RECEIVED
 JUL 23 1941
 ENGINEERING DEPT.
 CITY OF PORTLAND

Springers Jewelry
 515 Congress St.
 owner Mrs Howard Kirk
 Portland, Me.

APPLICATION FOR PERMIT

RE: D-F Sign for William M.
Cross, 515-A Congress St.
Portland, Maine

DETAIL FOR ANCHORING
IRON FACING ON
PARAPET LIGGETT BLDG
PORTLAND ME.

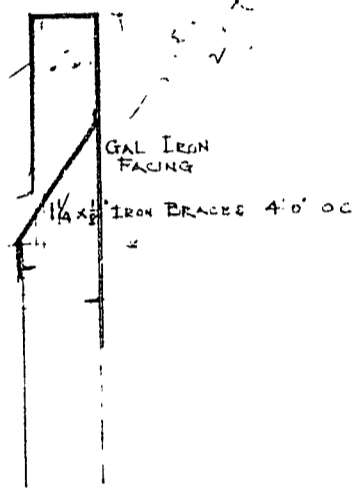
2. It is understood that the frame parapet wall is permissible under the Building Code, only because the present frame cornice is to be removed, the proposed wall being approximately equivalent in amount of woodwork and exposure to the cornice to be removed.

3. Woodwork of the proposed wall, otherwise exposed to the outside air will be covered with galvanized metal or equal, and this metal covering will be fastened to the masonry of the front wall of the building by means of metal bars at least 1/8 inch thick and 1 1/2 inches wide without the use of any wood or other burnable material in such fastenings, in such a manner that burning out or deterioration of any part of the woodwork of roof or proposed wall would not allow the metal covering to fall unless the masonry wall should fall. These bars will be provided, and securely fastened to both sheet metal and the masonry wall not more than four feet from center to center and in such locations that every separate sheet of which the metal covering is made up will have at least one such fastening.

4. The proposed parapet wall will consist of the following construction and fastenings, or equivalent in the opinion of the Inspector of Buildings:- the proposed wall shall not exceed three feet in height above the present roof sheathing at any point; a wooden shoe laid approximately flat on the present roof sheathing and spiked or bolted through into roof construction so as to penetrate the roof joists or wall plate reasonably; on this shoe 2" x 4" studs, 16" from center to center with a suitable plate along the top; on both sides of wall, all over on front and above new roof in back, will be tongued and grooved sheathing, and on this the sheet metal; iron braces of same thickness and width as specified above for sheet metal anchors, will be provided as near the two ends of the wall as practicable and not more than four feet centers in between, these bars to be at an angle of about 45 degrees with the vertical, each bar to be fastened to a stud by bolting through bar and stud as high as possible and still keep the bar below the new false roof, and the other end to be bolted through bar and roof joists, the bar being carried through the present roof for that purpose.

We shall be glad to revise the application for the permit calling for a masonry parapet wall of the required thickness, if you will so indicate and give us the correct unsupported height of the proposed parapet wall. If it is decided not to go ahead with the work, the fee of 75 cents will be refunded by voucher if you will return the receipt for the same to this office.
